Video Products Technical Bulletin 20-2008-065

SUBJECT: **REUSE PARTS WHEN REPLACING BN BOARD**

MODEL: **BKM-24N**

Figure 1

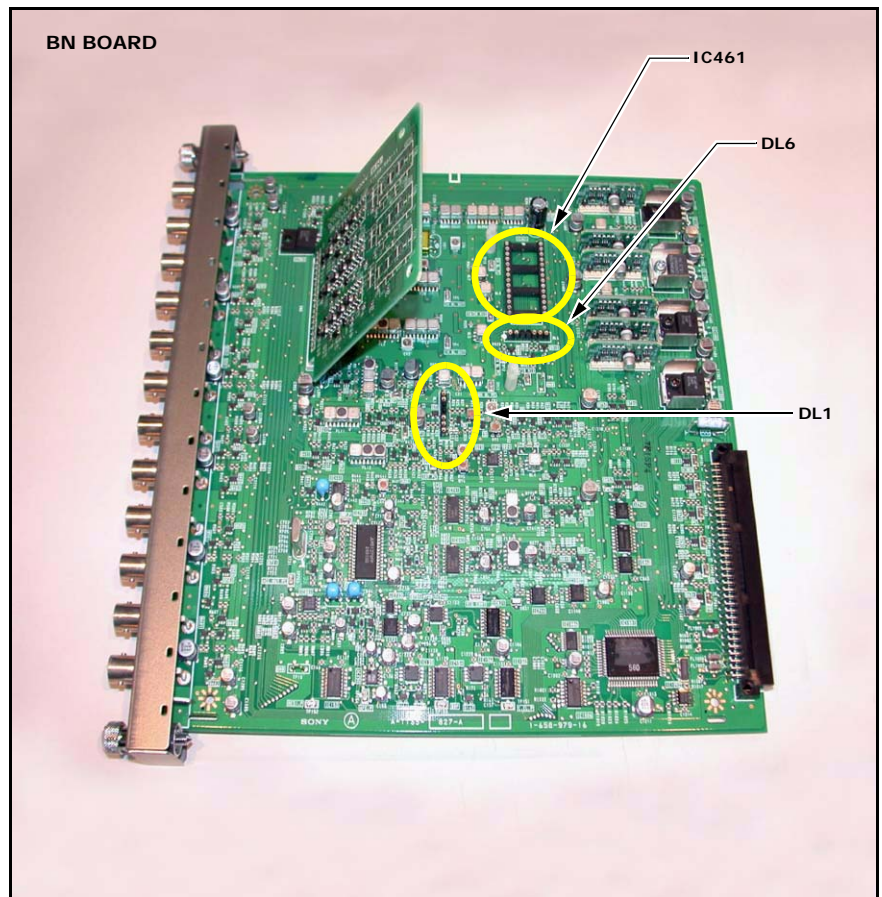
When you replace the BN board (A-1135-827-A), remove the following parts from the former board and install them on the new board.

Ref. No.	Description
IC461	IC CXA1539P
DL1	Delay line
DL6	Delay line

The new BN board does not contain the parts, and the parts are no longer available. (See Figure 1.)
